DEL-71-8.91 (PHASE A)

PROJECT DESCRIPTION

NO.	RFI	DESCRIPTION	REV. BY	DATE
PIR4	.	ADD SPEC. PROVISION	TAZ	04/10/25
.

TYPICAL TRANSVERSE SECTION
BRIDGE NO. DEL-00071-08.910
OVER I-71

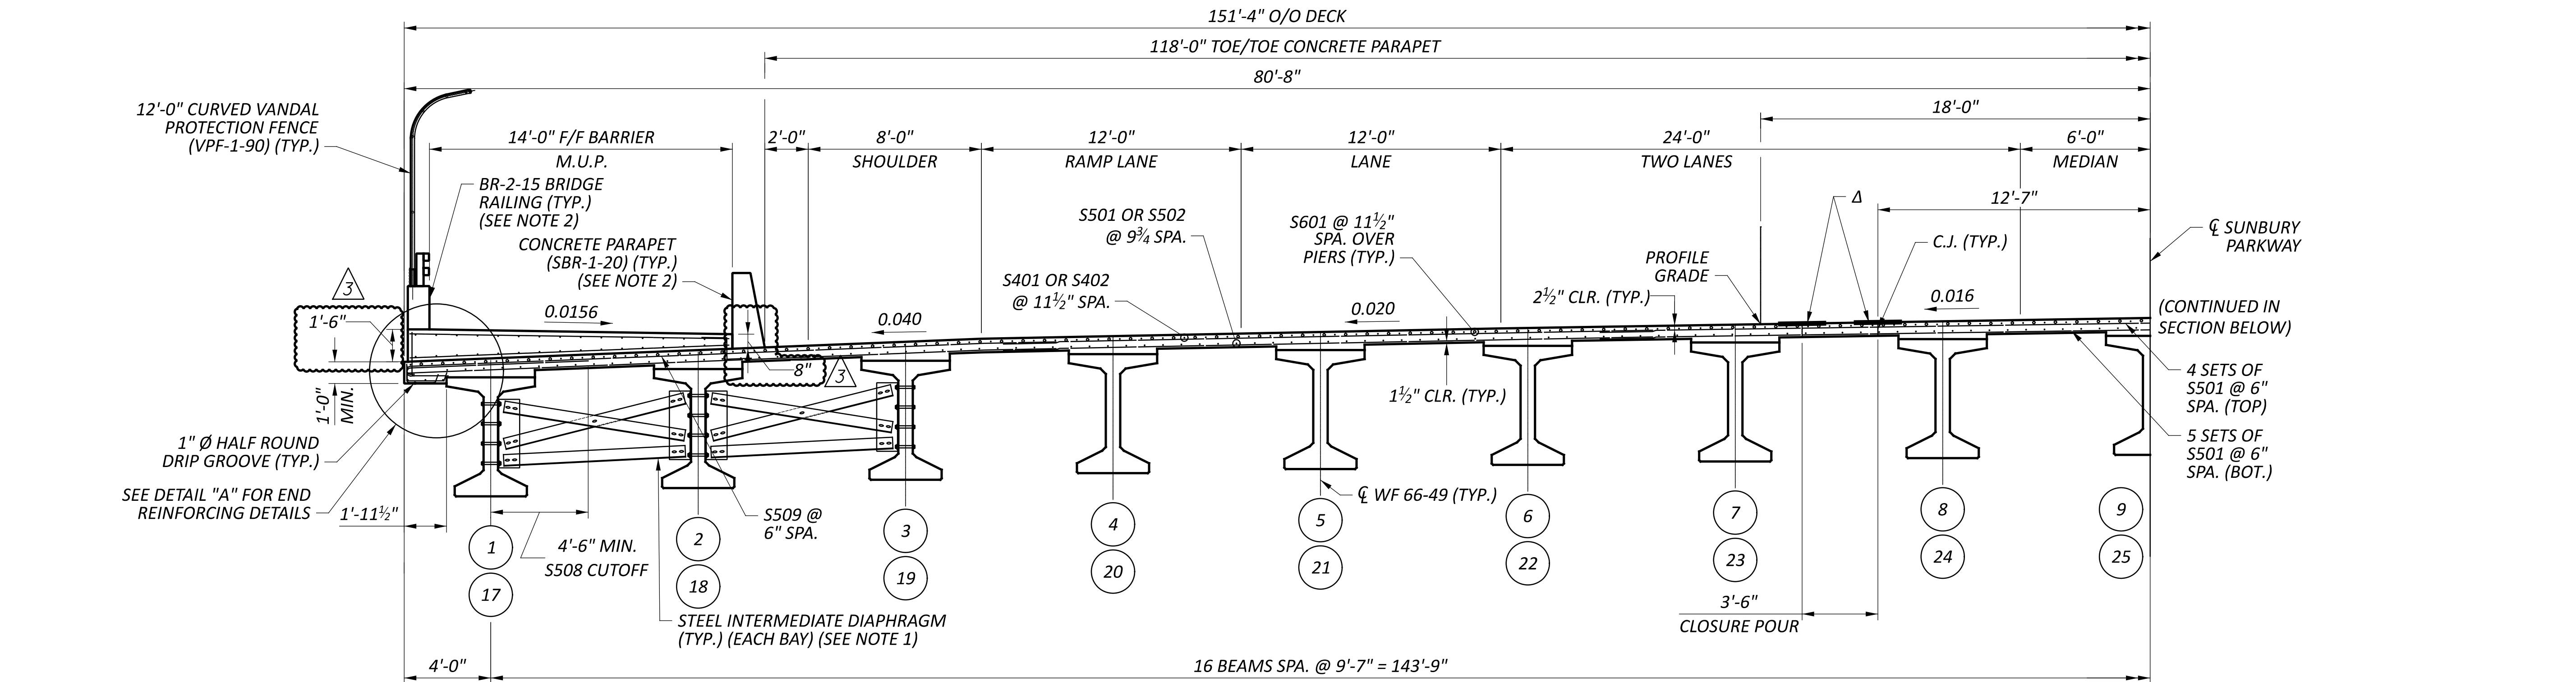
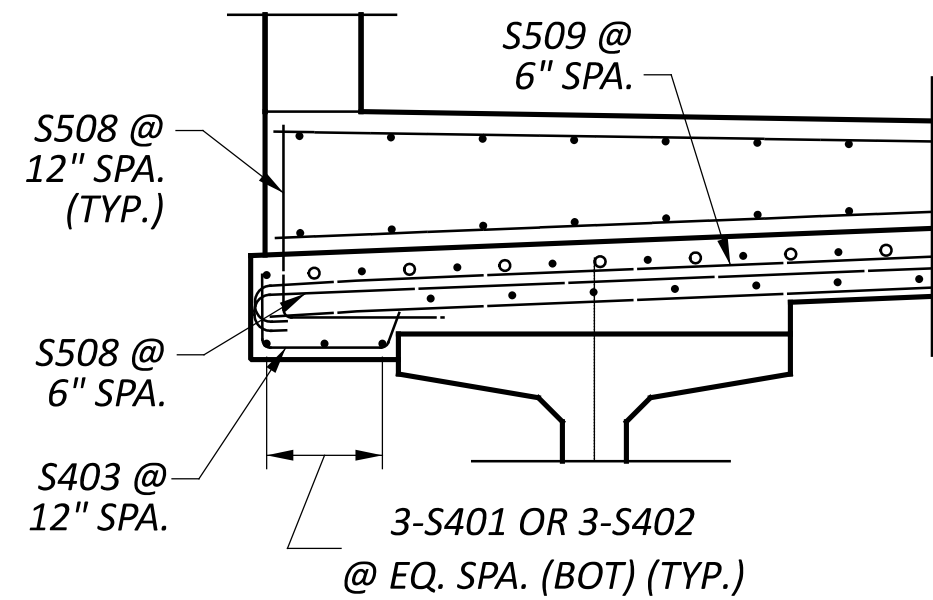
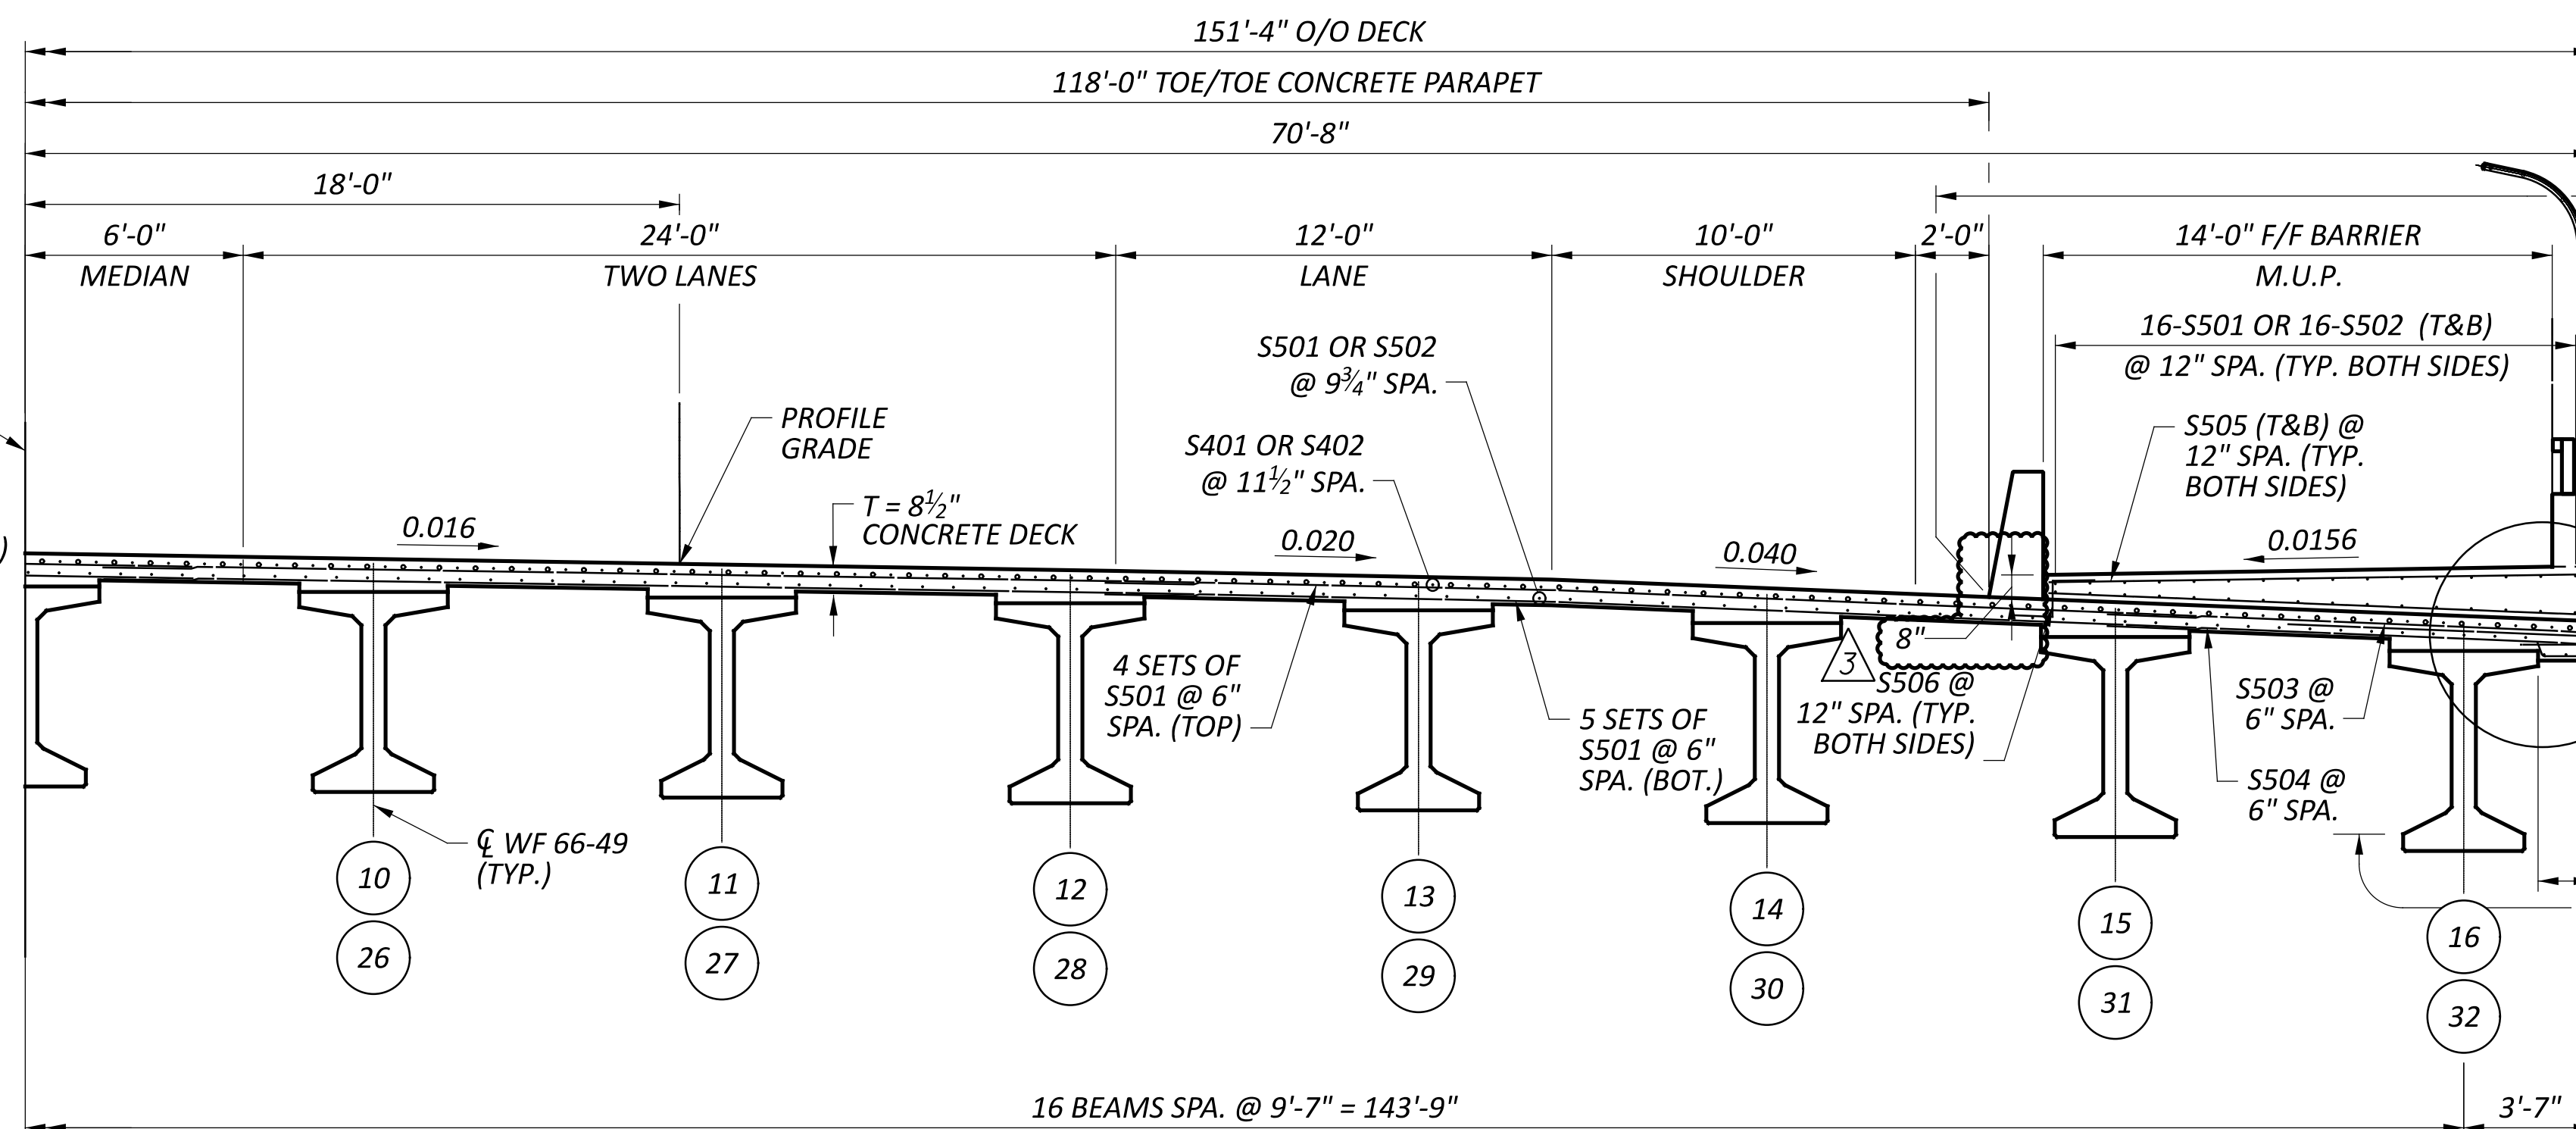
NO.	DESCRIPTION	REV.	BY	DATE
PIR3	ADDED SUP DIMENSIONS		ATM	03/14/25
